CITY OF ALBUQUERQUE

Re: GAHP INCA
3701,3705,and 3711 Inca St. NE
Traffic Circulation Layout
Engineer's/Architect's Stamp **05-17-19** (G21D044)

TRAFFIC CIRCULATION LAYOUT

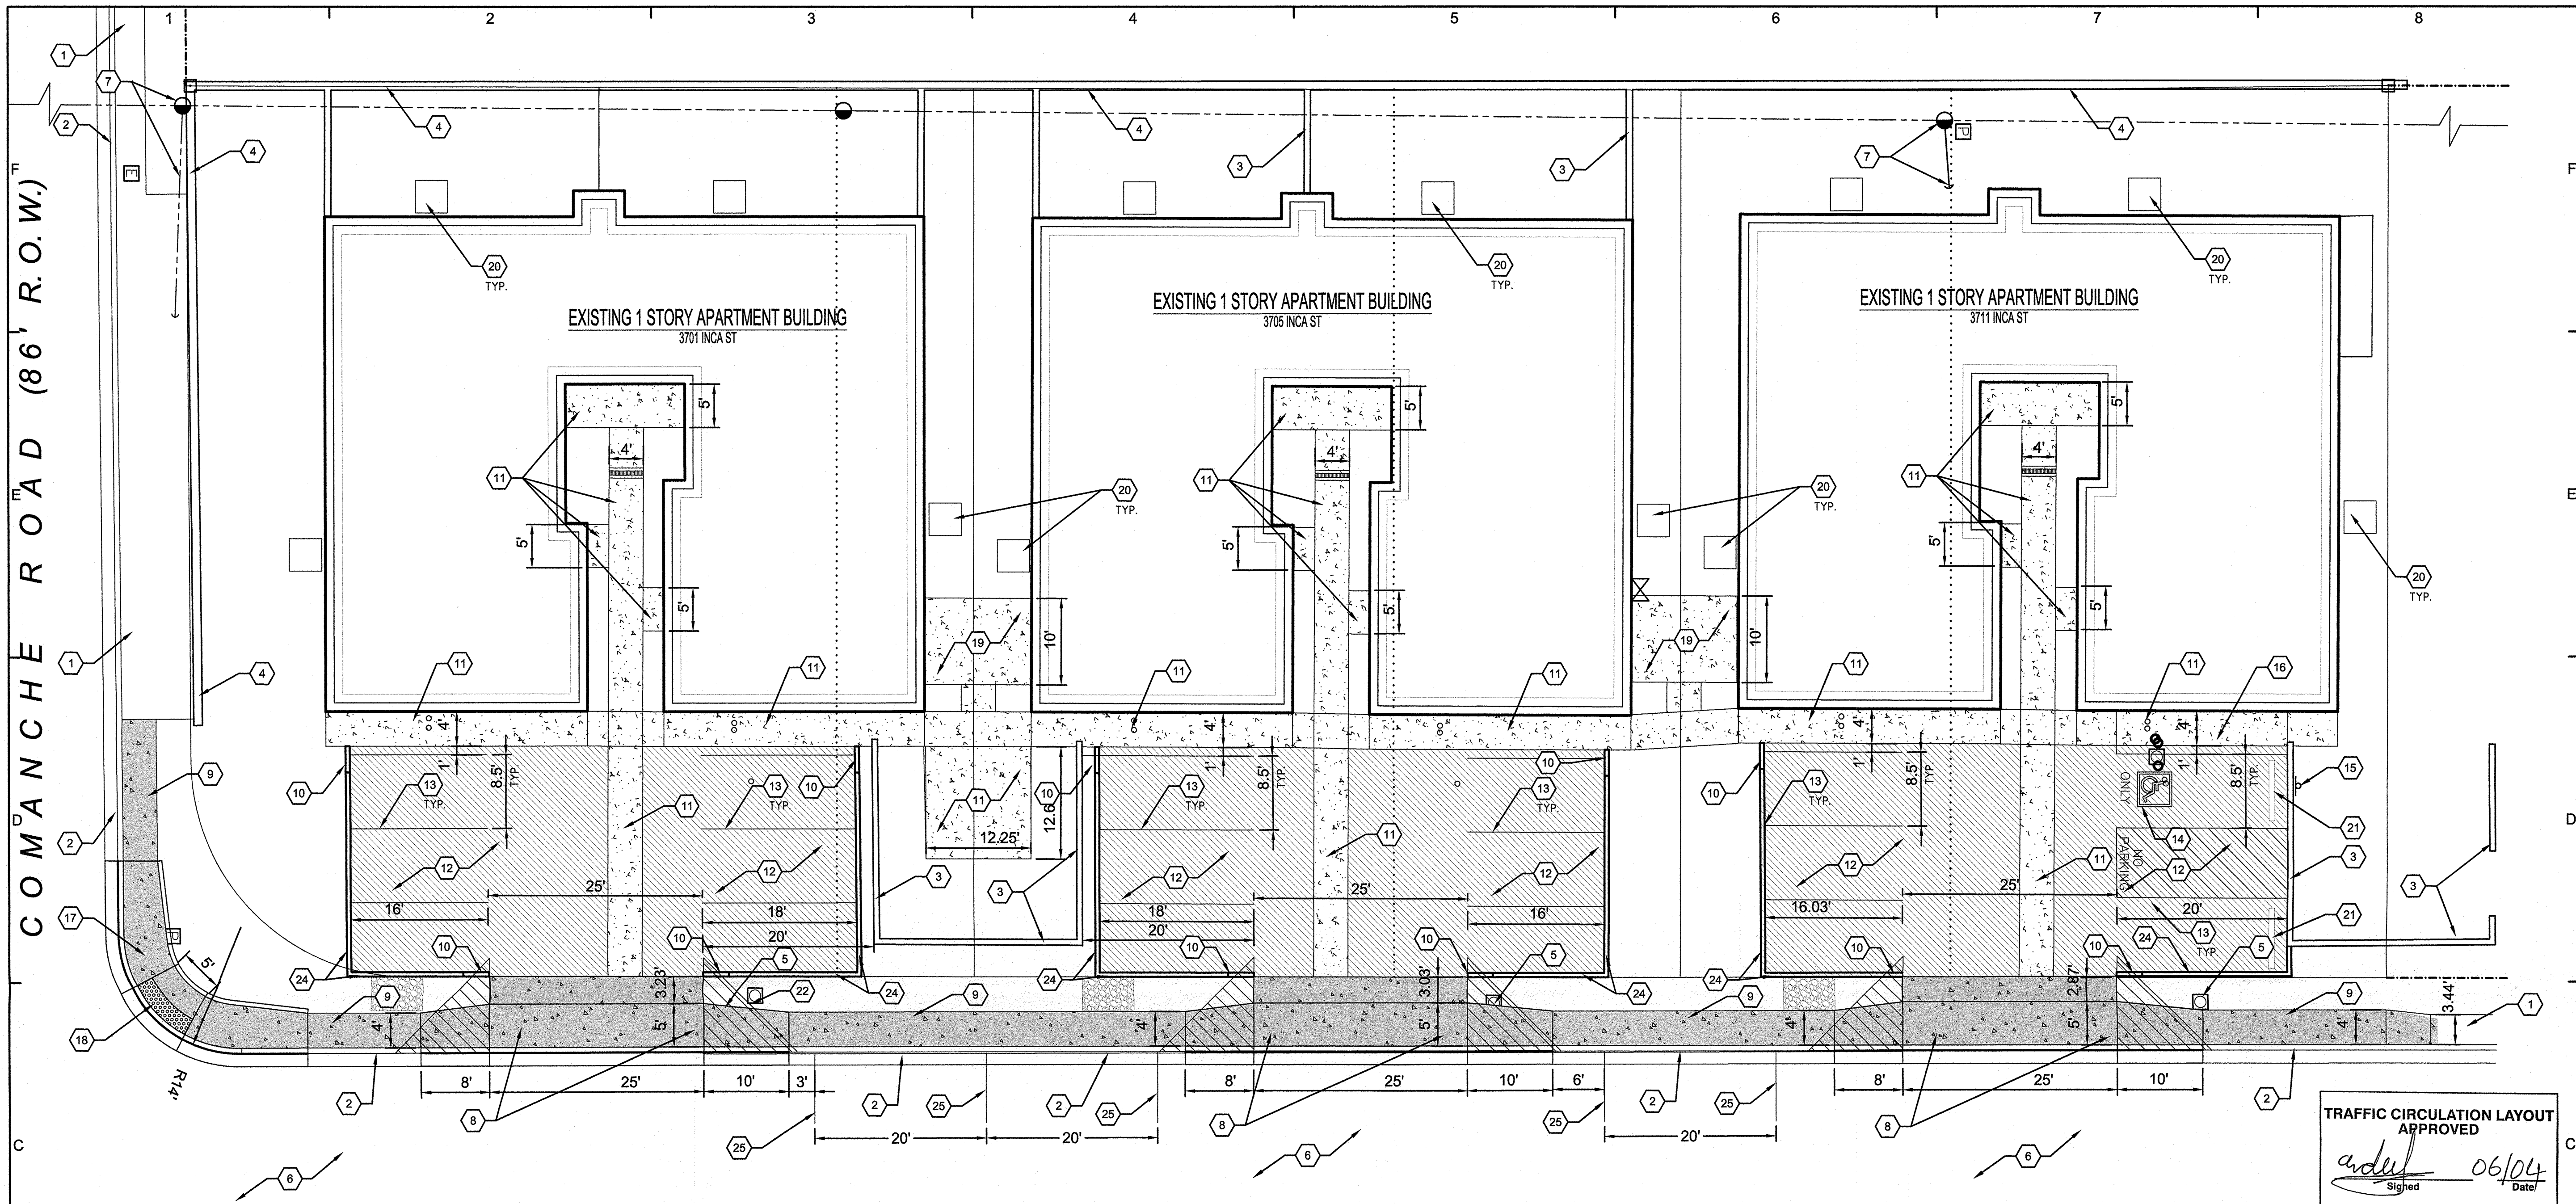
ALL WHEELCHAIR RAMPS LOCATED
WITHIN THE PUBLIC RIGHT OF WAY
MUST HAVE TRUNCATED DOMES.

ADD ADDITIONAL SIGN BELOW RESERVED PARKING SIGN OR VAN ACCESSIBLE SIGN THAT READS "VIOLATORS ARE SUBJECT TO A FINE AND/OR TOWING"
ACCESS AISLES AT ADA PARKING SPACES THAT BE LABELED WITH "NO PARKING"
